Date: May 22, 2006

To: T10 Committee (SCSI)

From: George Penokie (IBM/Tivoli)

Subject: SAM-4: Converting to UML part 1

Figure 4 — Logical unit class diagram

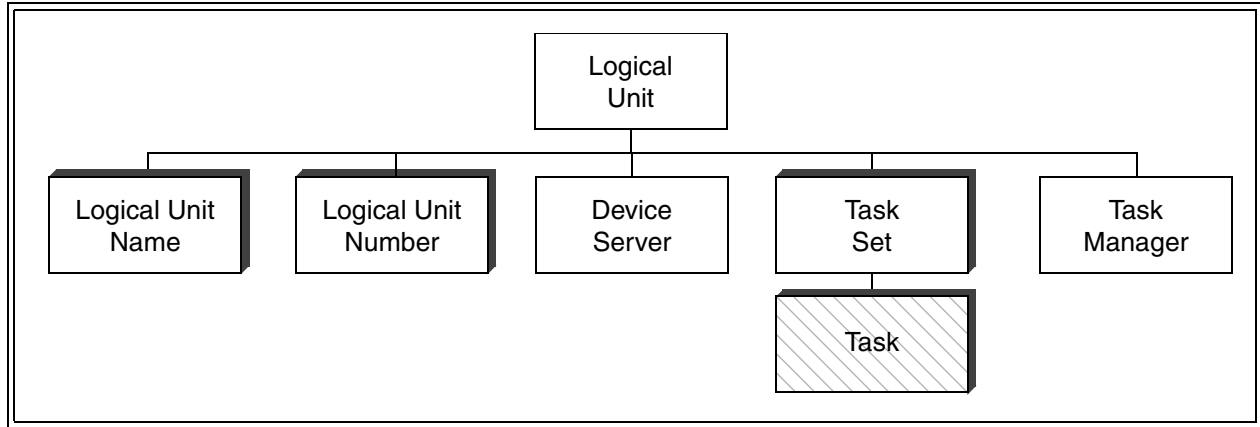
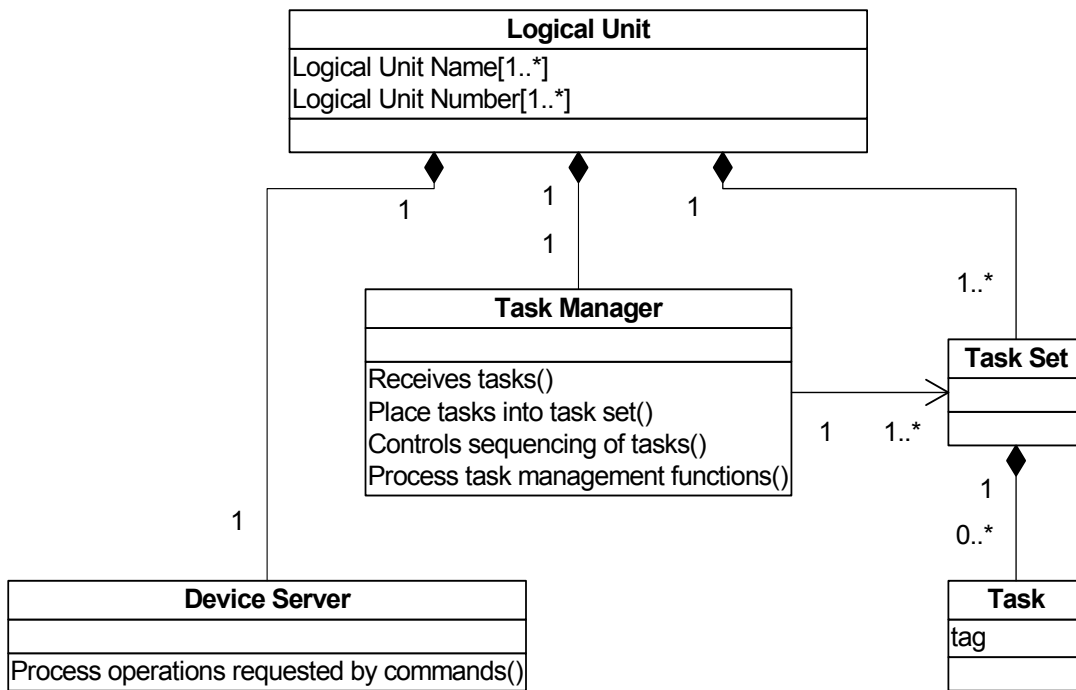
For an example of what figures in SAM-4 would look like a converted logical unit model (see figure 3) as currently shown in SAM-4 would look like what is shown in figure 4.
